# 1977 - 1978 Corvette: Service Bulletin: Rear Bumper Cover Wavy

**Subject:** Rear Bumper Cover Wavy  
**Model and Year:** 1977 - 1978 Corvette  
**Source:** Chevrolet Dealer Service Bulletin  
**Number:** 78-T-42  
**Section:** XIV  
**Date:** July 1978

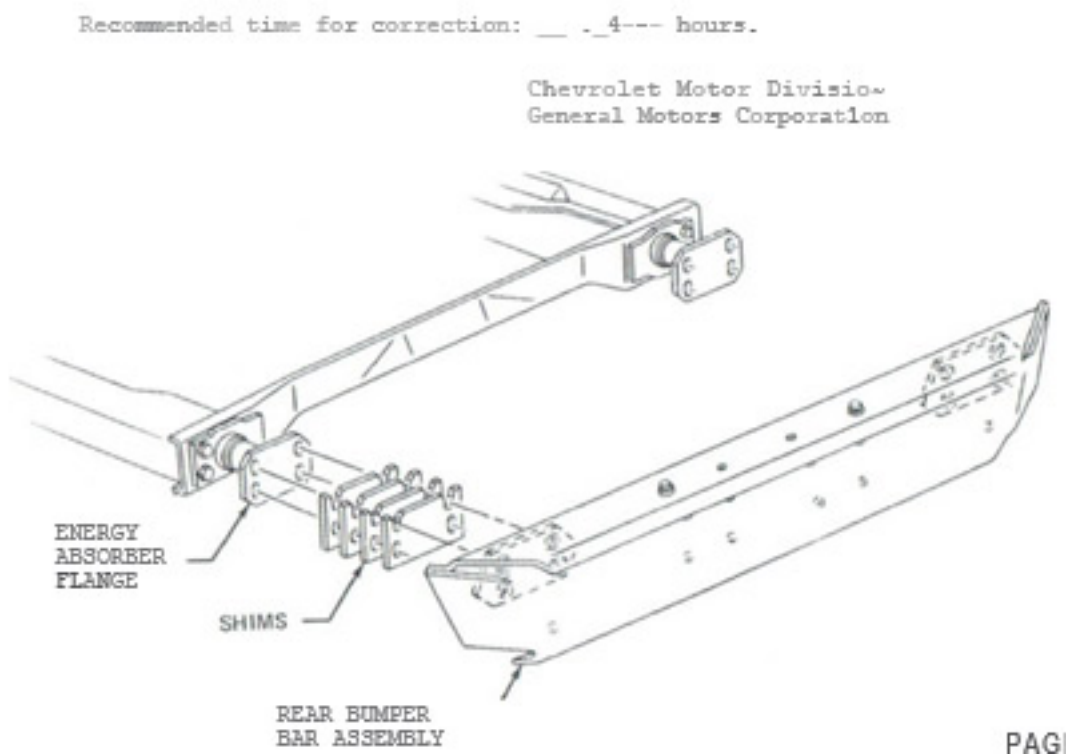
Some 1977-78 Corvettes may exhibit a wavy rear bumper cover above the tail lamps. This condition could be caused by the position of the rear bumper bar relative to the energy absorber. In January, 1978, the assembly plant started using a fixture to improve the adjustment of the bar, thus eliminating the distortion.

The appearance of a wavy cover can be improved using the following procedure:

1. Loosen the bolts which attach the rear bumper bar to the energy absorber assembly. See illustration. To remove depressions from the cover, raise the bumper bar. If the cover is bulged, lower the bar. If a satisfactory fit is obtained, tighten the bolts (70 Nm/52 ft. lb.). If the cover is still wavy, mark the bumper bar at the point of best vertical fit to the energy absorber.
2. Remove the lower two bolts on each side. Refer to illustration. Since the shims are slotted at the top, removal of the upper bolts is not required.
3. The bar is shimmed at assembly, but may not be at the optimum position. Adding shims (PIN 473279) will stretch the cover and removing shims will

relax it. Shims should be added or removed one at a time.

4. When a satisfactory cover fit is achieved, tighten the energy absorber to bumper bar bolts.

Each site must be adjusted independently. Due to manufacturing tolerances, one side of the bar may have more shims than the other and be at a different position in the energy absorber slots.
